Los Angeles Regional Water Quality Control Board

SUBJECT: REVIEW OF DRAFT REMEDIAL ACTION PLAN; CLEANUP AND ABATEMENT ORDER NO. R4-2021-0079 AMENDMENT

SITE: SKYPARK COMMERCIAL PROPERTIES (ASSESSOR PARCEL NO. 7377-006-906), 24701 – 24777 CRENSHAW BOULEVARD AND 2530, 2540, AND 2600 SKYPARK DRIVE, TORRANCE, CALIFORNIA (SCP NO. 1499, GLOBAL ID NO. T10000014333)

N:\GIS\Proj\S042.002_Hishear\QGIS\QZ and GPKG\20220601\QZ322_S042.002_Hishear.qgz Figure 20 - Proposed Groundwater Sampling 2021-03-26T15:56:13.000 Created by: initial Checked by: initial

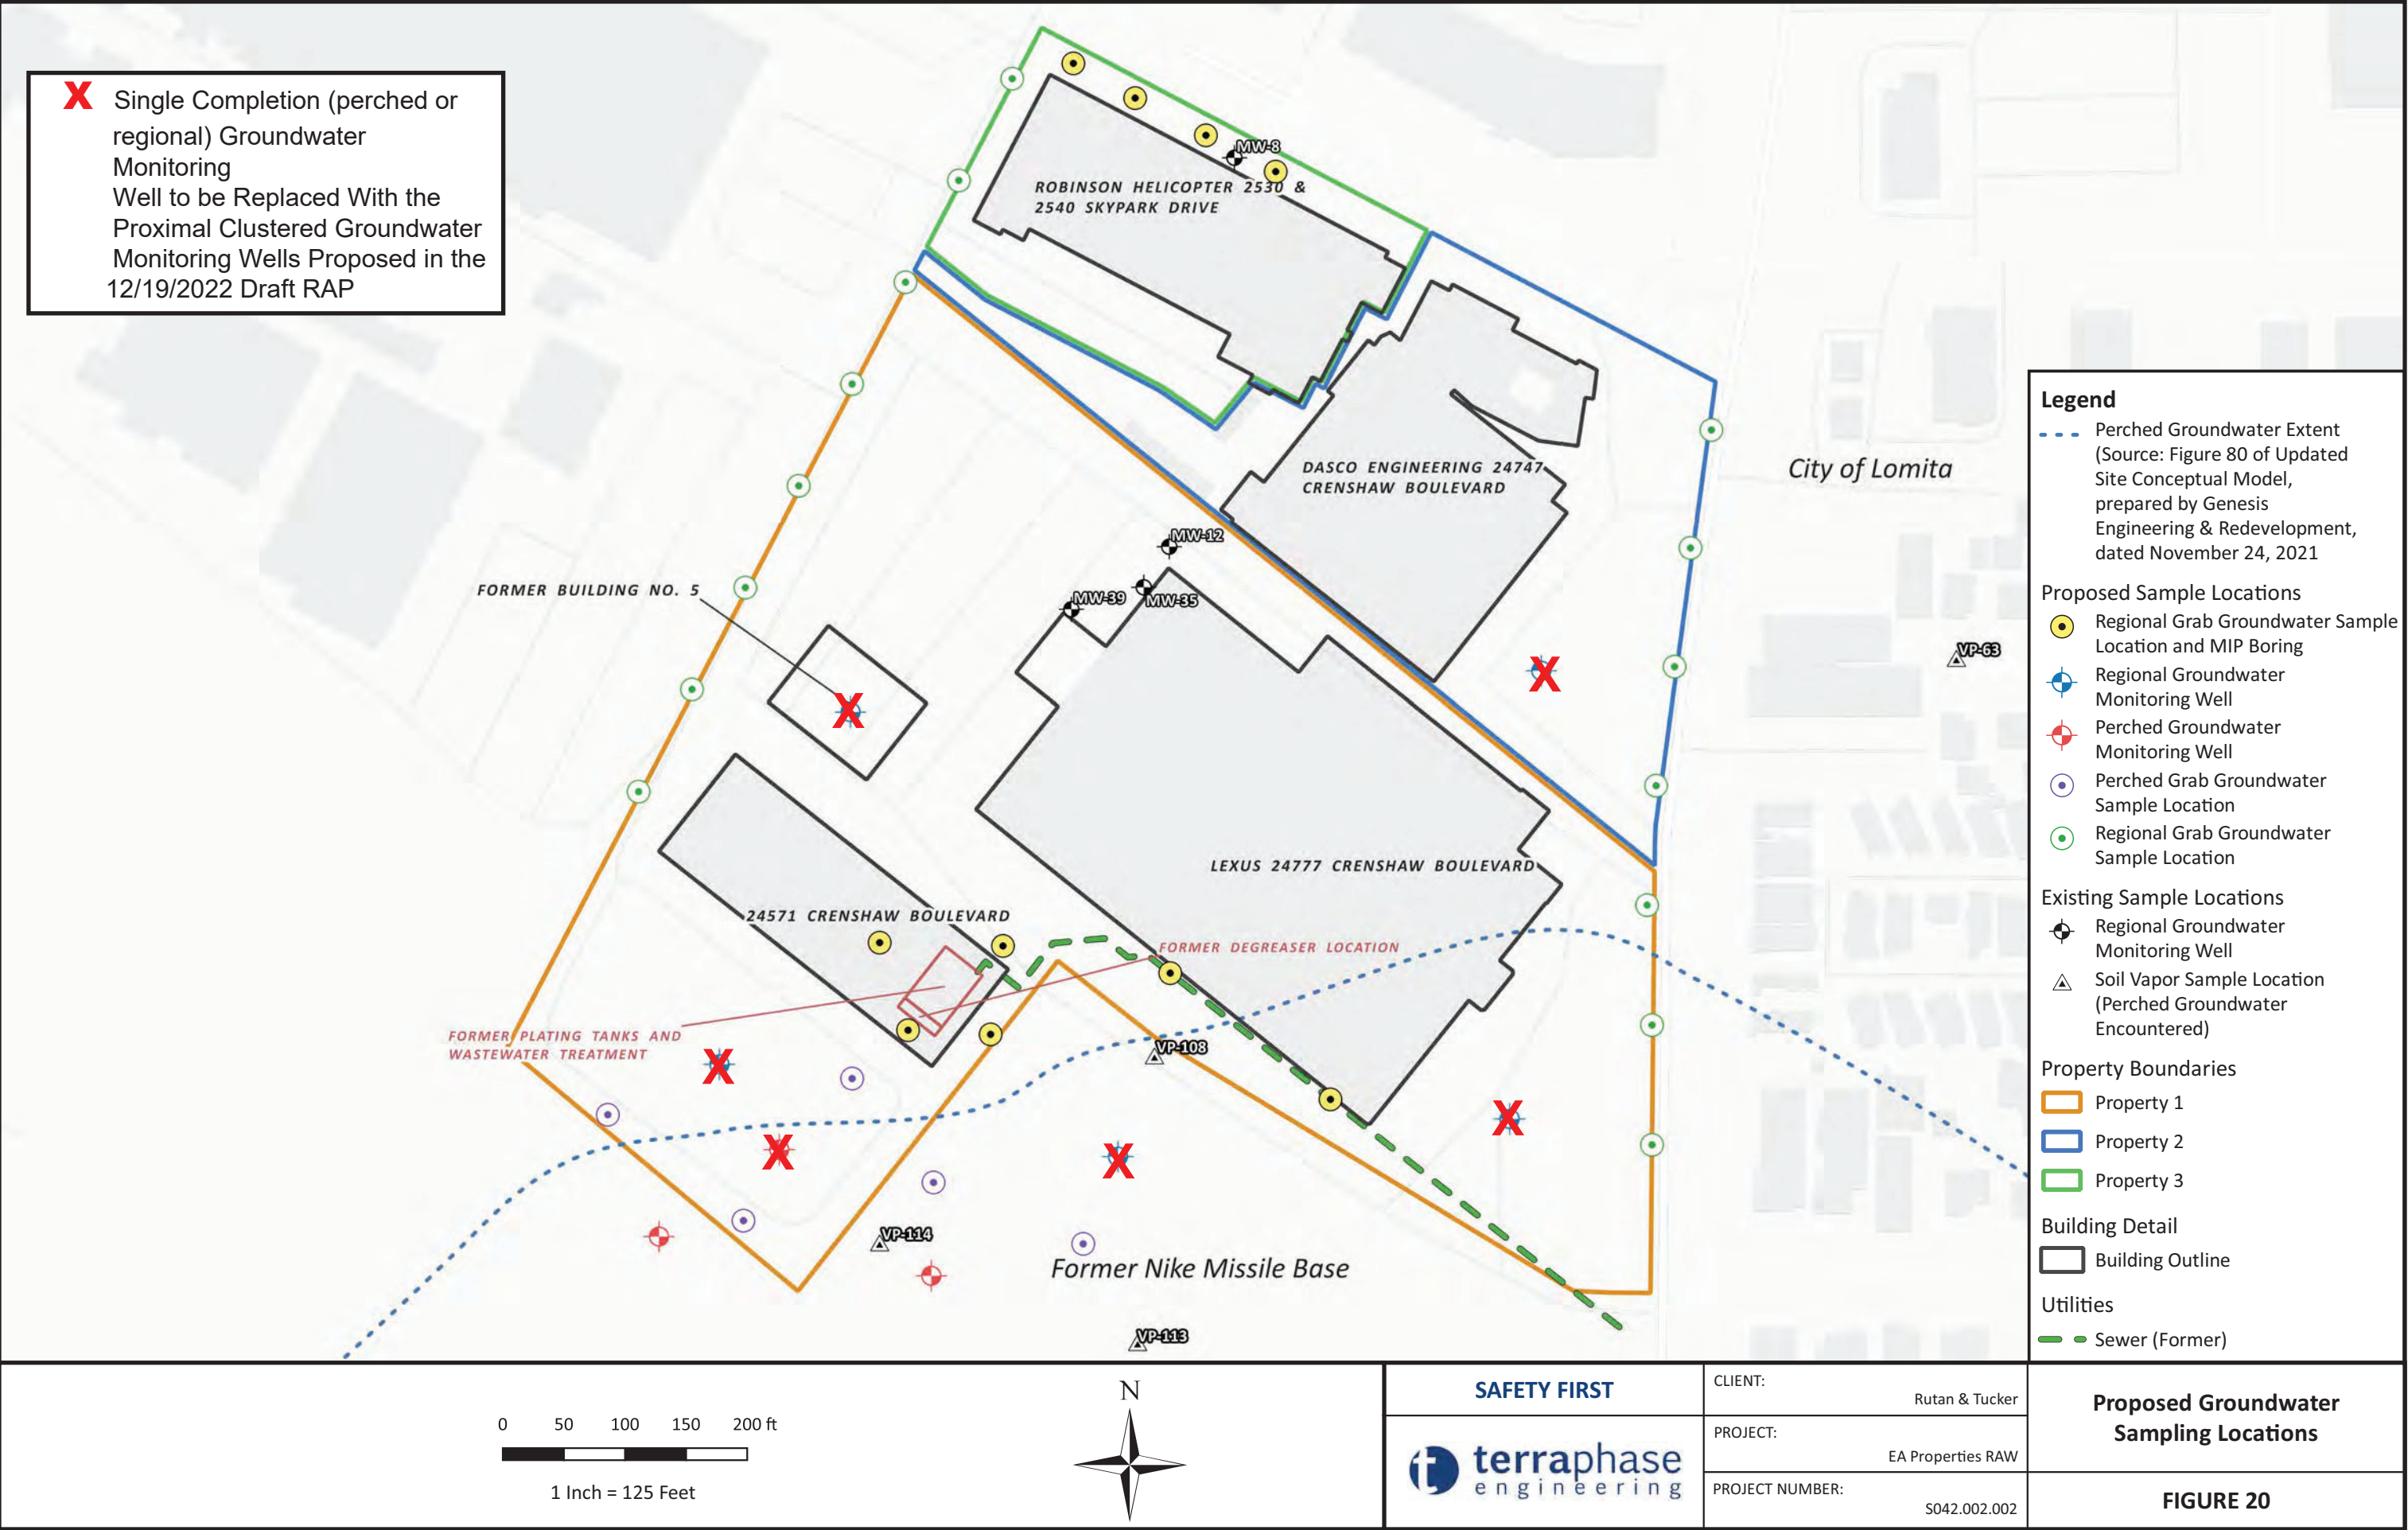
- i. The one perched and five regional groundwater monitoring wells proposed and conditionally approved in the investigative component of the Revised EAP IRAP are to be replaced by the clustered groundwater monitoring wells proposed in the Draft RAP. Attachment 7, *Los Angeles Water Board Modified Figure 20 – Proposed Groundwater Sampling Locations* shows the locations of the perched and regional groundwater monitoring wells from the investigative component of the Revised EAP IRAP that will be replaced (marked by red X's). Attachment 8, *Los Angeles Water Board Modified Figure 23 – Proposed Groundwater Sampling Locations, Regional Groundwater Remediation Area, Vadose Zone, and Perched Groundwater Remediation Areas* shows the locations of the clustered groundwater monitoring wells and the perched and regional groundwater monitoring wells (marked by red X's) that do not need to be installed.
